Reference: NHTSA Identification Number 08V-583

Revised December 2008

Safety Recall H37

Gearshift Cable

Figure 6

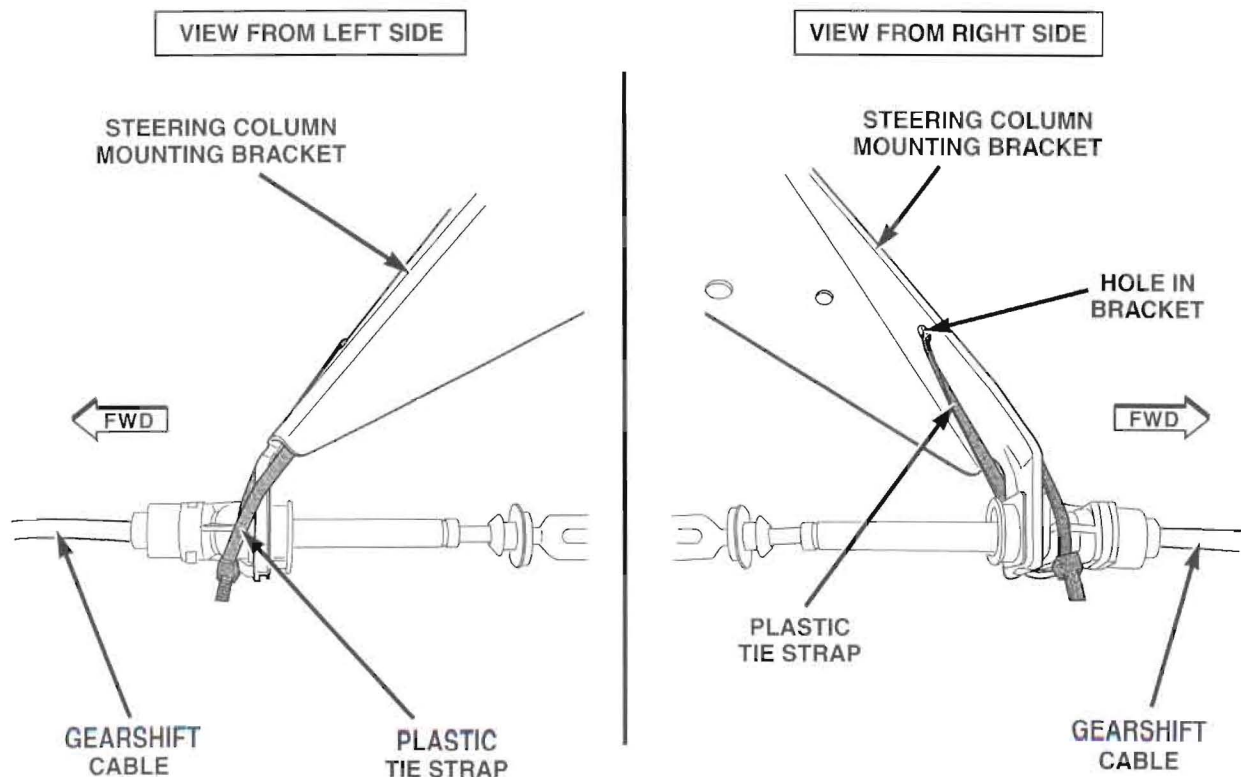
10. Install a plastic tie strap around the cable base and steering column mounting bracket as shown in Figure 6.
11. After installing the plastic tie strap, cut off the excess end of the tie strap.
12. Install the silencer panel into position and install the two push-in fasteners (Figure 3).
13. Install the Energy Absorbing (EA) bracket and three mounting bolts. Tighten the bolts to 62 in. lbs (7 N·m) (Figure 2).
14. Connect the trunk release switch and snap the knee bolster into position.
15. Install the two knee bolster retaining screws. One screw is located in the door jam, the other screw is located on the bottom of the instrument panel knee bolster.
16. Install the instrument panel side trim cover at side of the instrument panel (Figure 1).
